TECHNICAL BULLETIN

018

June 2017

PLUNGER OIL SEAL for pumps XLT – XXT – NLT – PXI – MXT - MPX

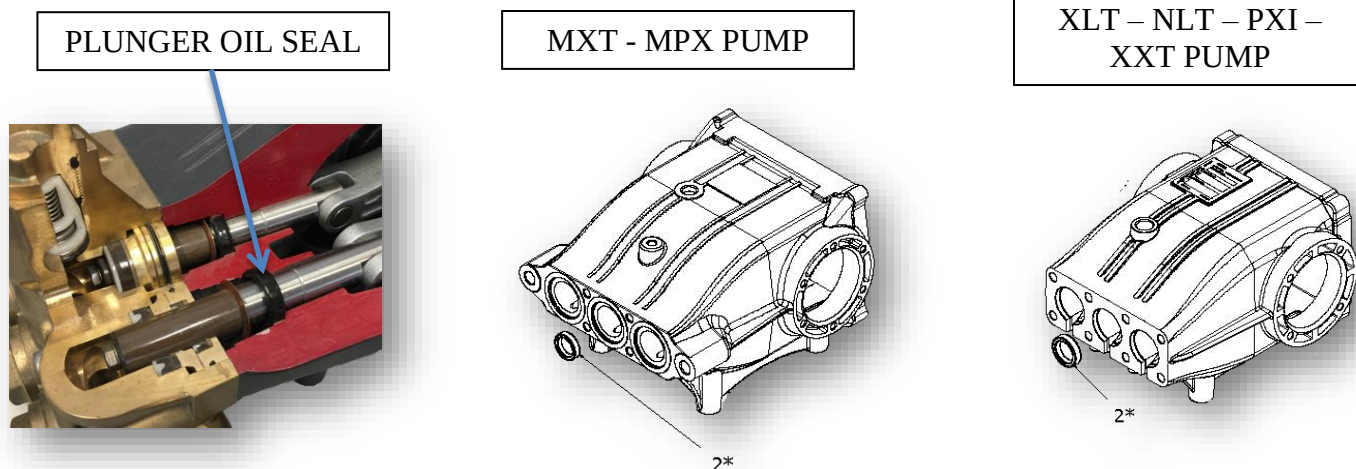
- The plunger oil seal has been upgraded to provide now better performances.
- The new plunger oil seal (2) is interchangeable with the old plunger oil seal(2)
- The kit “PLUNGER OIL SEALS” part number 1.099-766.0 is just available with the new plunger oil seal.
